City of Sugar Hill Planning Staff Report **RZ 19-004**

SUBJECT: Rezoning RZ-19-004, 4359 Woodward Mill Road

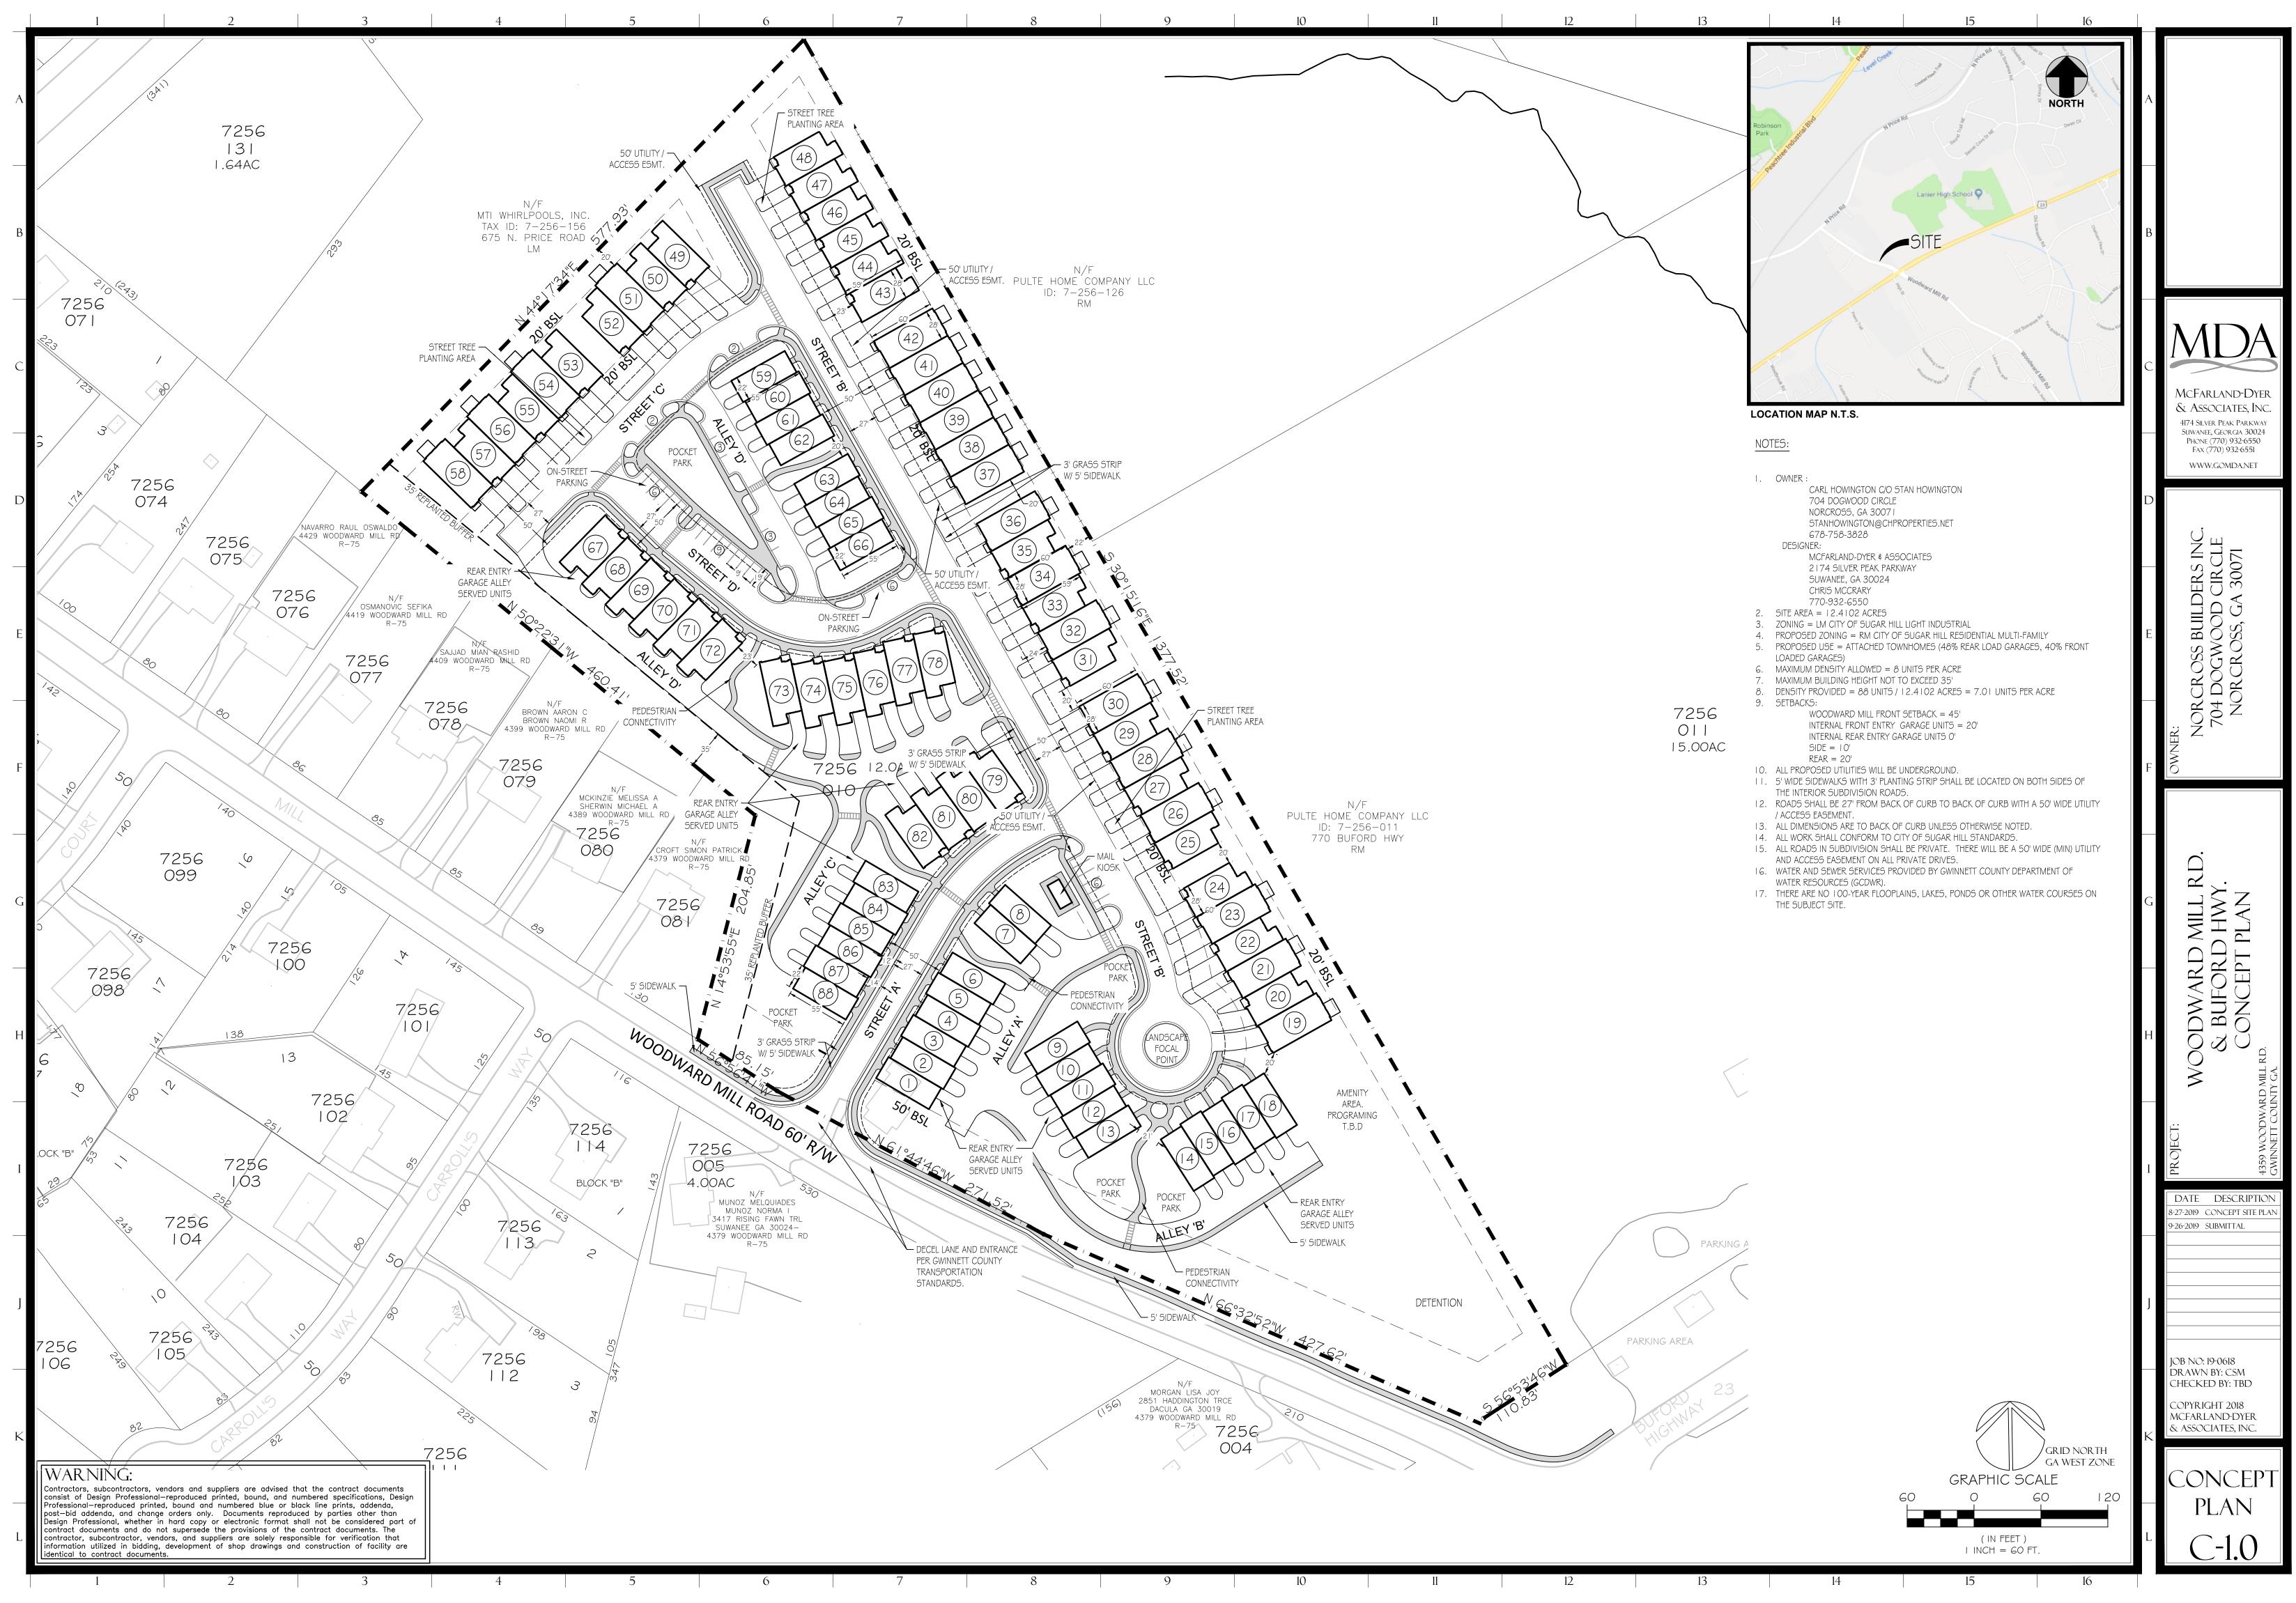
The proposed conceptual site plan appears to show the alignment of Woodward Mill Road prior to the 2011 intersection improvements.
